**RE: Ekins East Mine M/049/032, Utah County, Utah  
Notice of Intent to Commence Large Mining Operation  
Responses to Comments**

**Responses to  
Review Comments**

**RESPONSE TO INITIAL REVIEW COMMENTS  
FOR  
EKINS EAST MINE M/049/032, UTAH COUNTY, UTAH  
INTERMOUNTAIN AGGREGATE CORPORATION**

EXHIBIT A: ROAD IDENTIFICATION

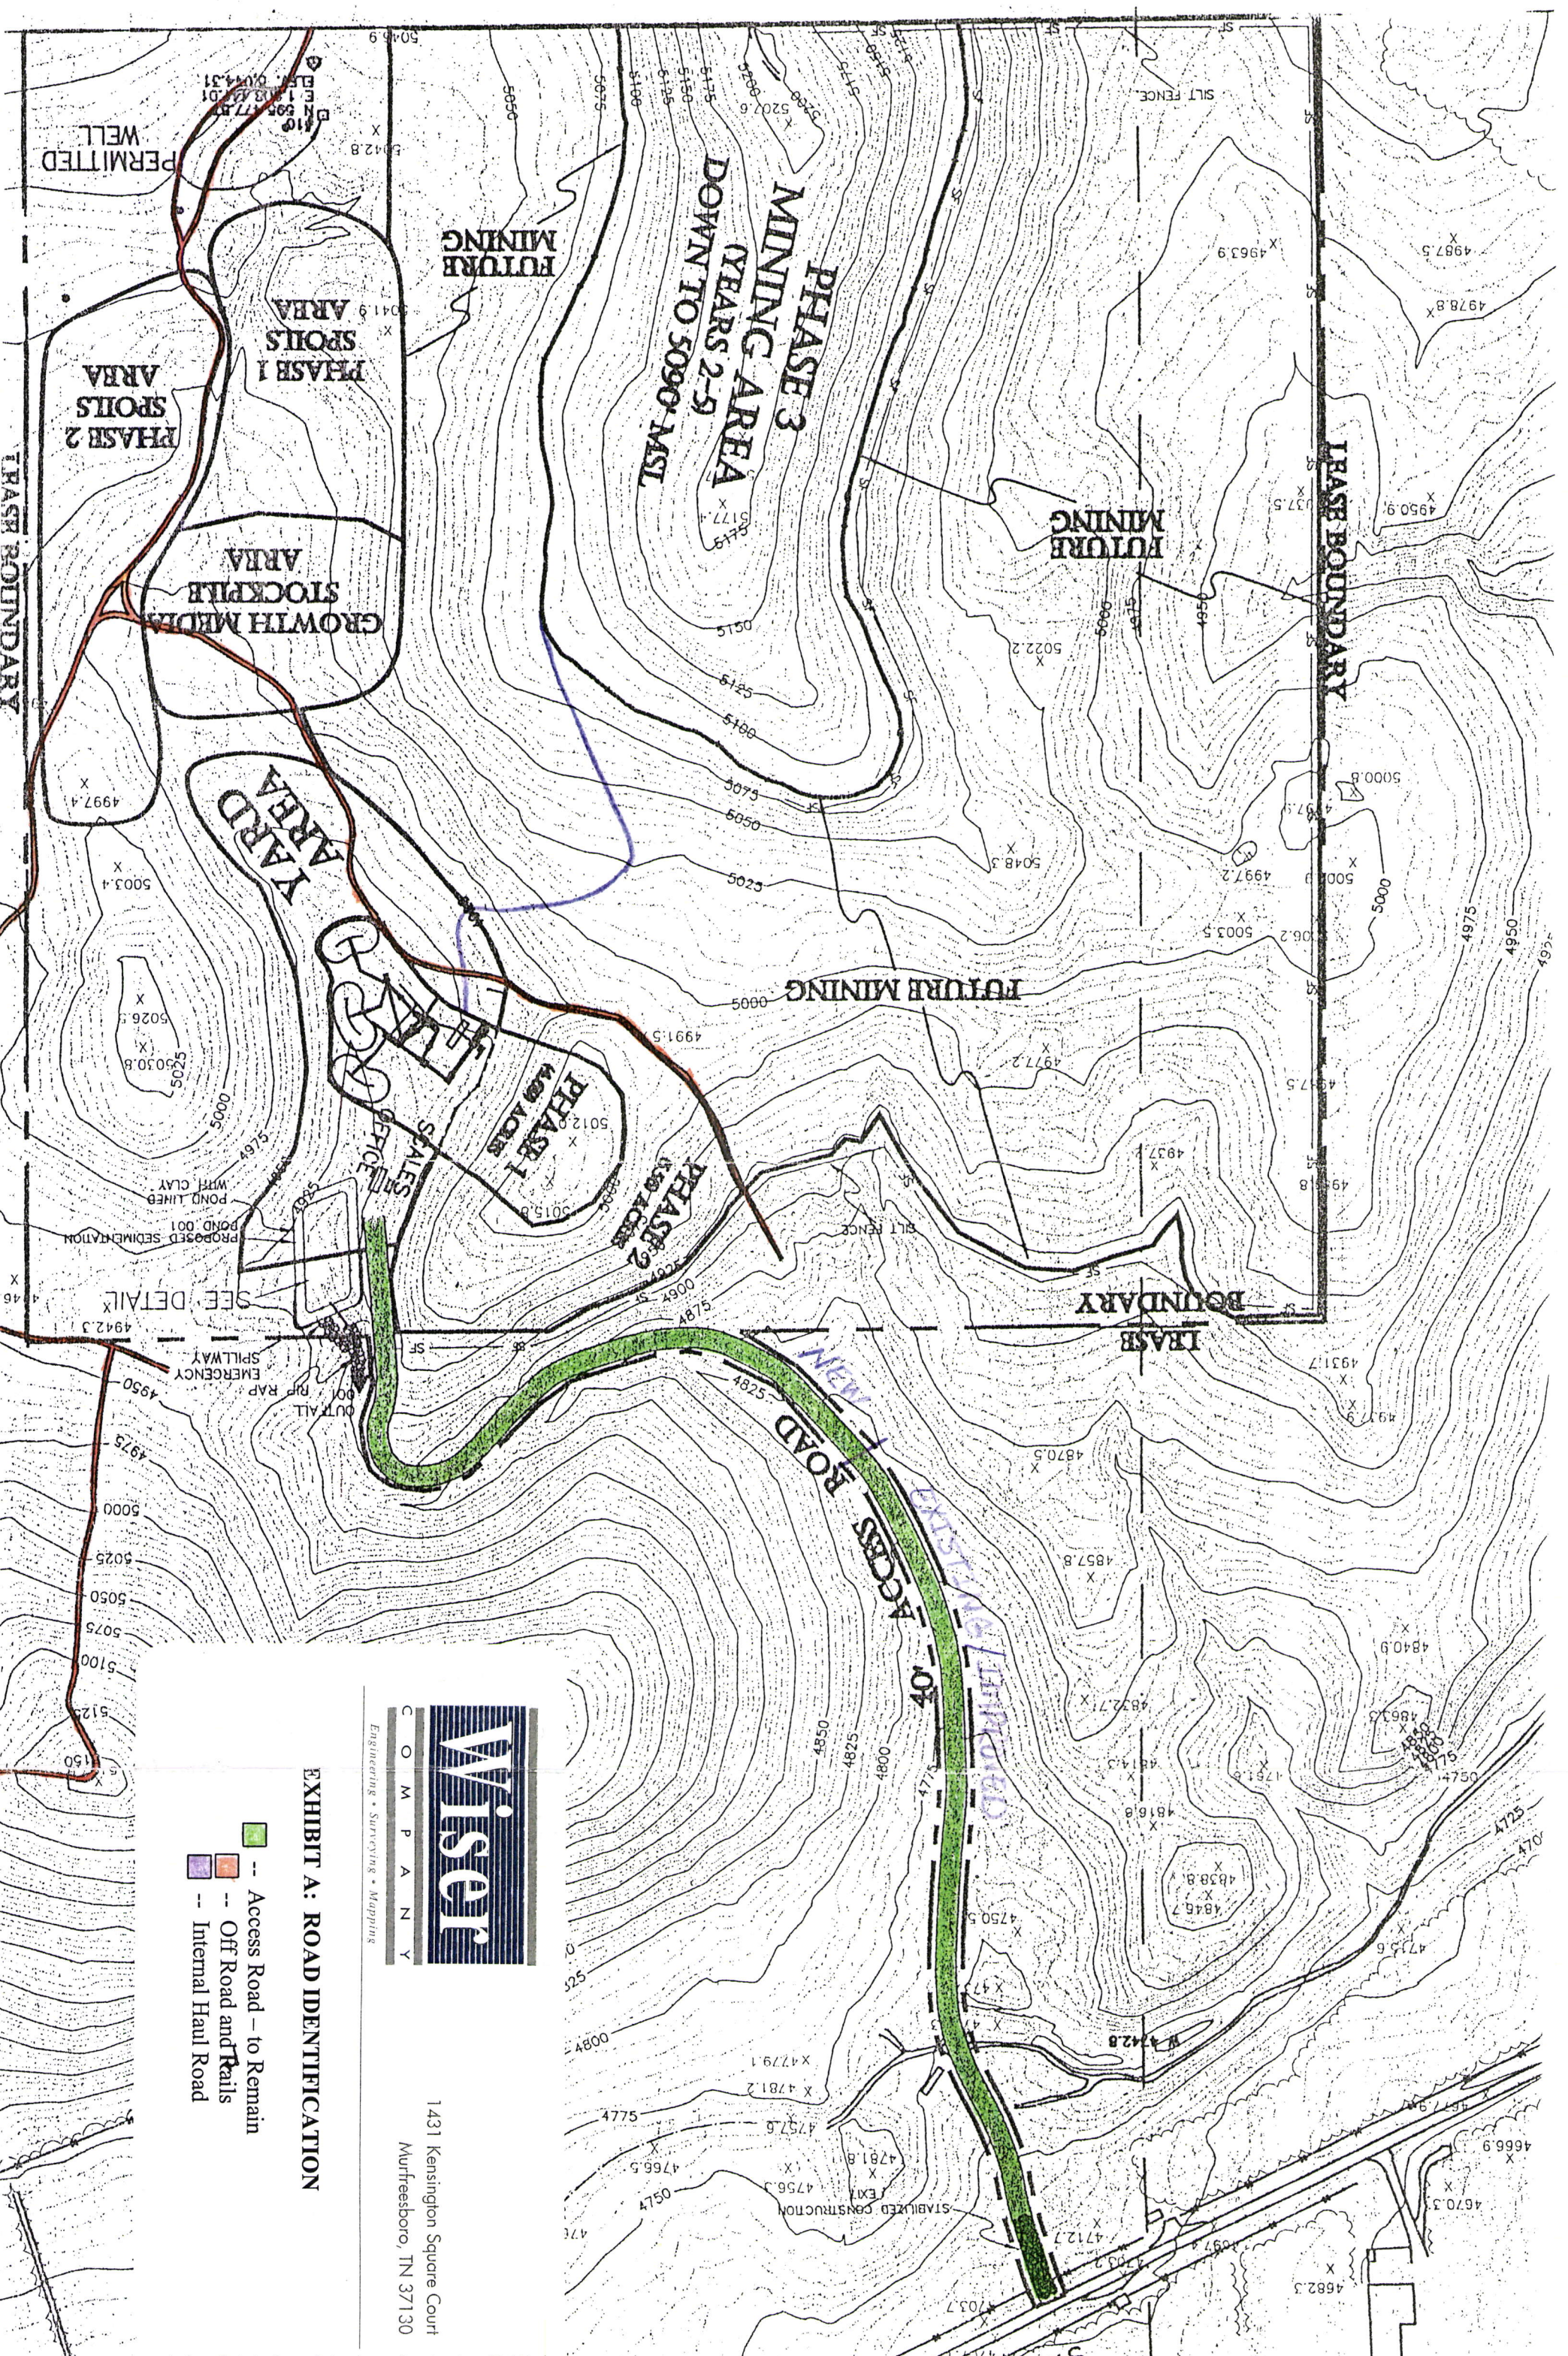
- 105.1 Comment: *There are several sections of road leading through the spoils and mining areas which are not identified as existing or new disturbances.*

Response: Please refer to Exhibit A which color codes the roads as "existing/improved roads," "new roads," and "off-road trails." The mapping compilers depicted the existing off-road trails within and near the site. Some of these exist in areas that will be disturbed and are therefore included in disturbance areas. An existing off-road trail which is substantially worn enters the property from State Highway 6. This existing road will be improved and become a part of the primary access road. It will be paved as required by the Utah County Planning Department. The owner is requesting that this access road remain.

**RECLAMATION TREATMENTS MAP**

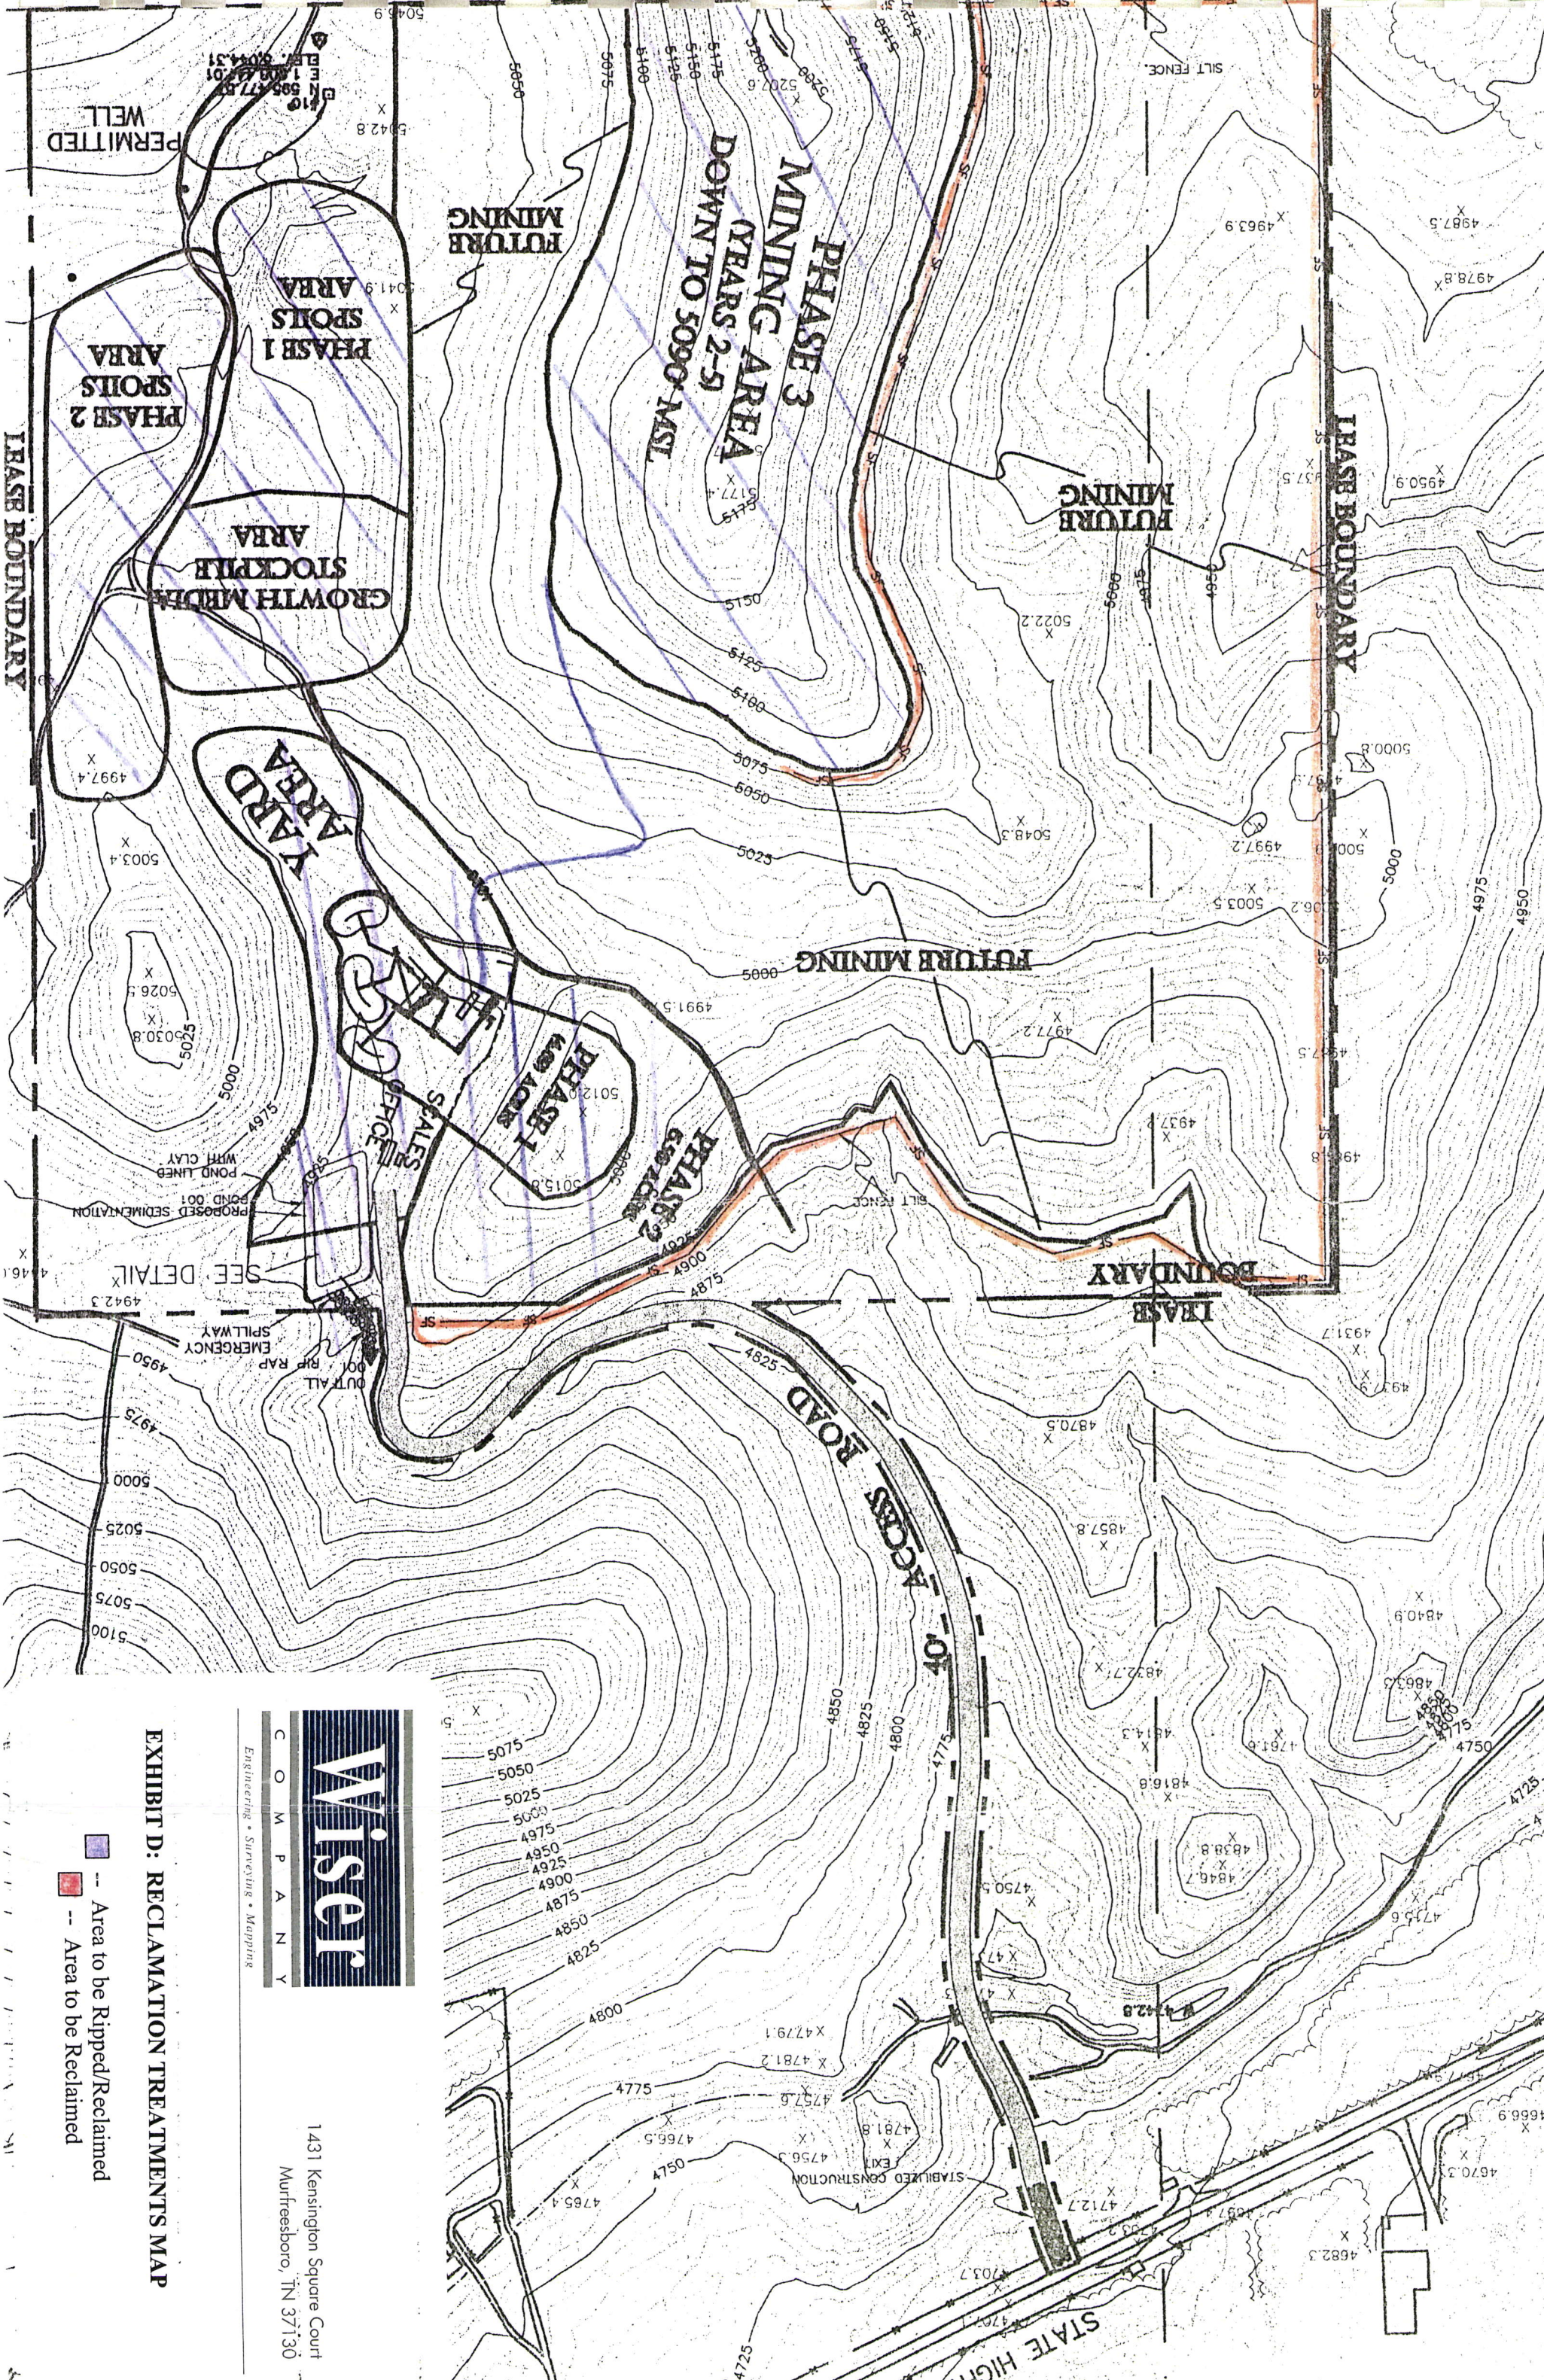
Comment: *Provide a "Reclamation Treatments" map.*

Comment: *Identify the area of disturbance to occur in the first five years.*

110.2 Comment: *Please clarify which sections of the access road if any are proposed to remain unreclaimed.*

Response: Please see Exhibit D, "Reclamation Treatment Map."

Response: Please see Exhibit D, "Reclamation Treatments Map." The disturbed area will consist of a total of 62.6 acres. The silt fence not previously included is now included.

Response: The section of entrance road from Highway 6 to the scales and office will not be reclaimed. Please see Exhibit D which depicts the road location and the area being reclaimed.
